Zoning Staff Report

Case Number: SP-21-025

Site Plan

NORTH CITY DRIVE
 MULTIFAMILY DEVELOPMENT

SITE PLAN

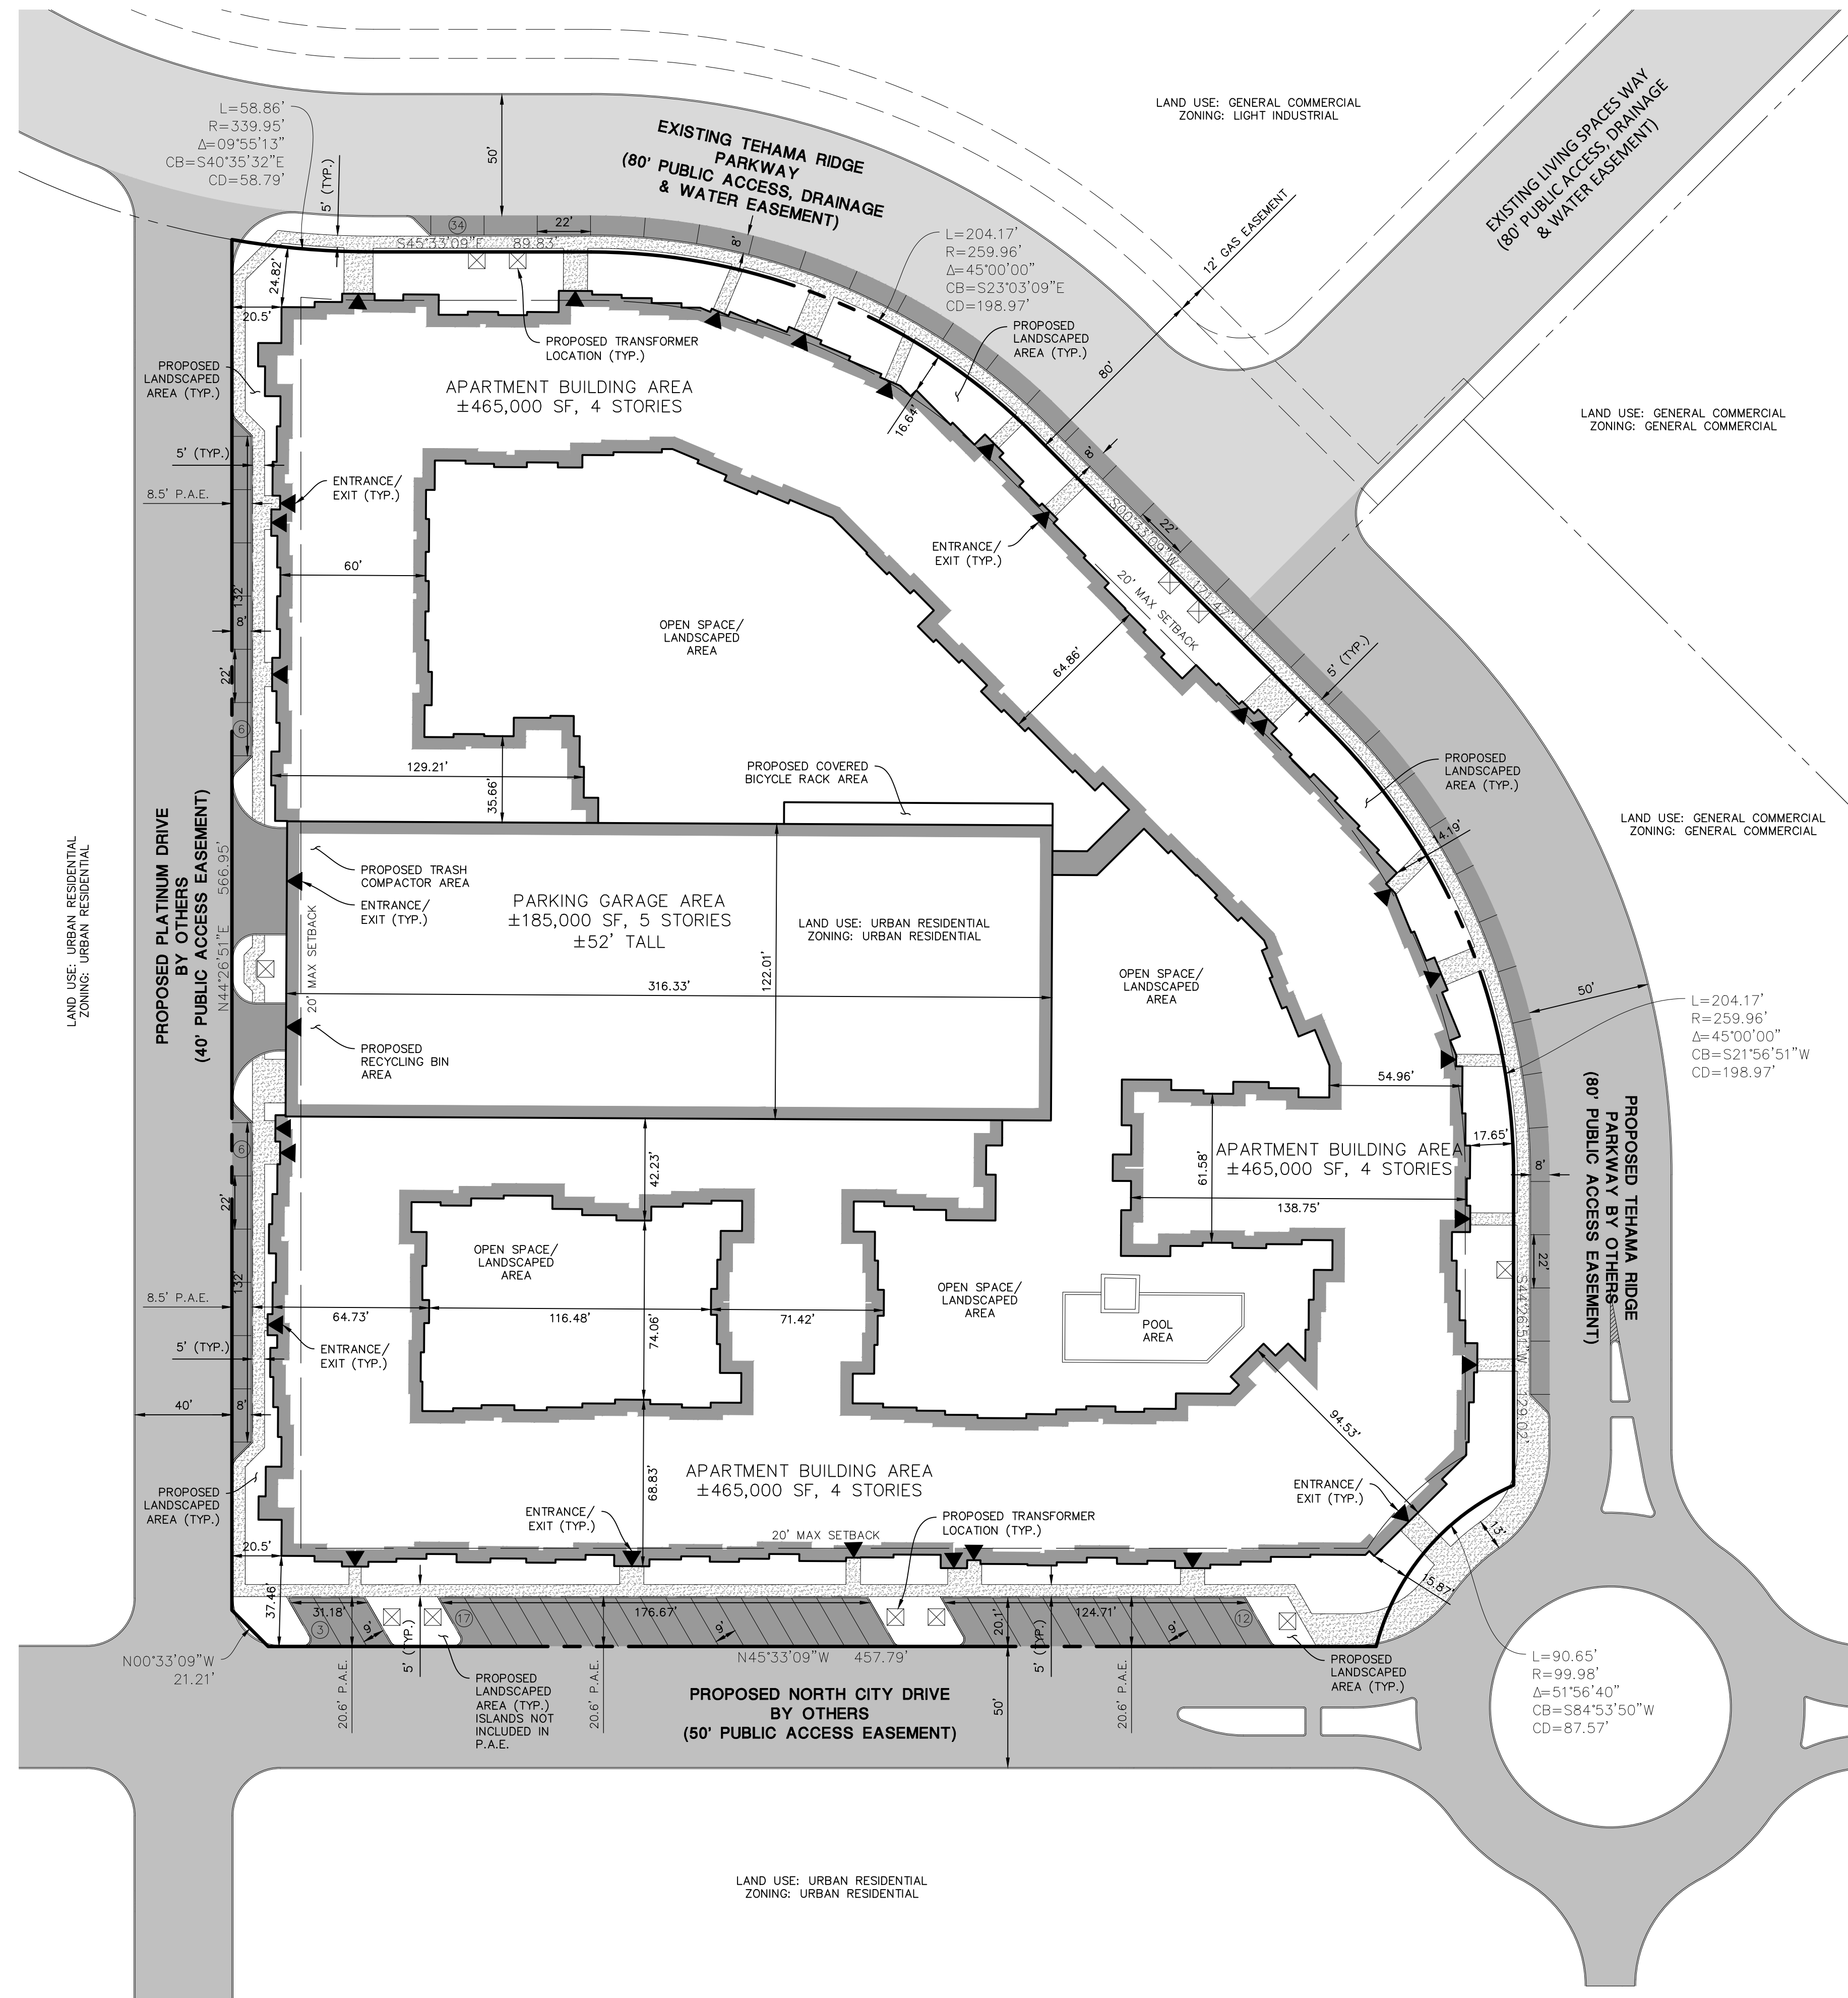
- ~~Can't determine compliance on rooftop screening, street tree plantings & pedestrian lighting. Need separate exhibits to verify or note with intent to comply.~~
- ~~Need to place all on-street parking spaces within a public access easement.~~
- ~~Provide unit count on Site Plan~~
- ~~Update note 7, should be "4.713.h.1" instead of "Article 4 Signs"~~
- ~~Fill in case # SP-21-025~~
- ~~Amend signature line to "Director of Development Services"~~

- The site plan matches PP-20-074.
- Two points of access are required for Multi-family. Access can be provided from marked fire lanes or from public streets. In this case, the surrounding streets provide access to the structure.

- IFC 2015/CFW Adopted Amendments Jan 1, 2017 Section 503.1.2 Secondary Access
- Hose lay is measured from the edge of a street or fire lane and should provide hose lay to all portions of the building within 150 feet, measured along a 5' wide unobstructed path. That distance may be increased to 300 feet for sprinklered buildings. Standpipes may be required within the open space areas to accommodate hose lay.

- IFC 2015/CFW Adopted Amendments Jan 1, 2017 Section 503.1.1 Buildings and Facilities
- Minimum fire lane or fire access road width is 26', as required for Multi-family structures.

- IFC 2015/CFW Adopted Amendments Jan 1, 2017 Section 503.2.1 Fire Lane Specifications
- Fencing that obstructs hose lay path can be cleared by installing 5' wide walk gates or vehicle gates that are a minimum of 20' wide when fully opened. All gates for this purpose must be equipped with Knox Locks.

- A building which is more than 55 feet in height shall be accessible by a dedicated street or fire apparatus access road that is not less than 15 feet nor more than 25 feet from the inside curb to the building face along at least one-half of the length of two sides of the building. Building height for this purpose is measured from the lowest level of fire access road to the floor level of the highest occupied floor.
- IFC 2015/CFW Adopted Amendments Jan 1, 2017 Section 503.1.4 Buildings Tall Than 55'
- No additional named easements are required. Street names shown on this site plan are correct or approved.

All zoning comments have been addressed as of 12/1
